Response to

Request for Additional Information No. 111 (1446, 1471, 1508), Revision 0

U. S. EPR Standard Design Certification

SRP Section: 06.02.02 - Containment Heat Removal Systems

Figure 06.02.02-8-2—TSP Basket Location With Respect to the ECCS Sump Blockage Design Mitigation Features

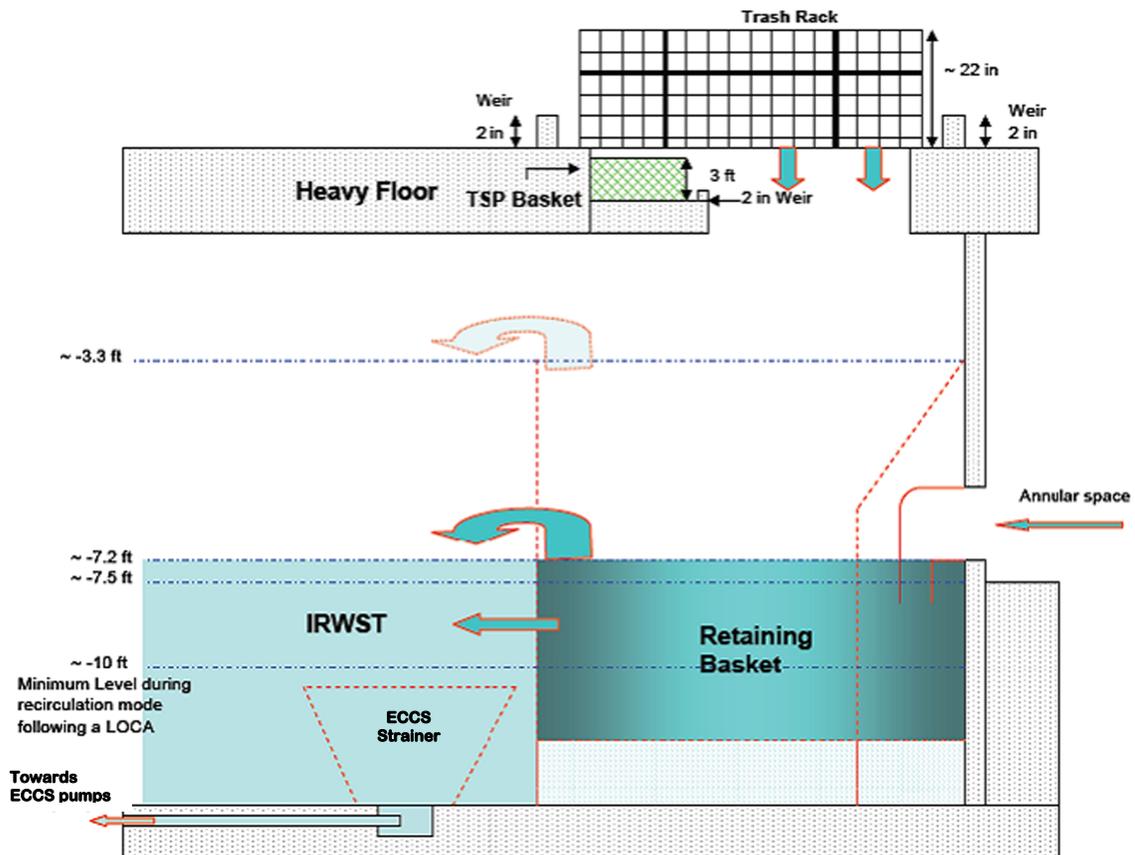
3. FSAR Section 6.3.2.2.2 discusses buffering solution. Please clarify how chemical buffer (TSP) is arranged within the boundary perimeter of the weir/trash rack.

9. Per ANP-10293, each of the retaining baskets has approximately the same screen surface area for screening out debris. Please provide a sketch or drawings that outline how these baskets and subcompartments, as applicable, are arranged and highlight credited surface areas used to perform their design functions. What is the minimum basket volume and surface area needed to support flow from the heavy floor? What is the minimum basket volume and surface area needed to support flow into the compartment dedicated to annular flow? Provide the basis for these volumes and surface areas.

1. The response will be provided by March 15, 2009.
2. The response will be provided by March 15, 2009.
3. The tri-sodium phosphate (TSP) baskets are located in the containment heavy floor opening below the IRWST trash racks. Figure 06.02.02-8-2 shows the location of the TSP basket for each of the four heavy floor openings and its relation to the ECCS sump blockage mitigation design features.

8. The total combined volume of the two single compartment retaining baskets is 3000 ft³.
9. See Figure 06.02.02-8-2 in item 3 above. The minimum requirements for the retaining baskets needed to support the heavy floor are 1589 ft³ and 721 ft². The minimum requirements for the smaller compartment of the double compartment retaining basket needed to support the annular space are 530 ft³ and 269 ft². These sizes are based on collecting all debris in one retaining basket.
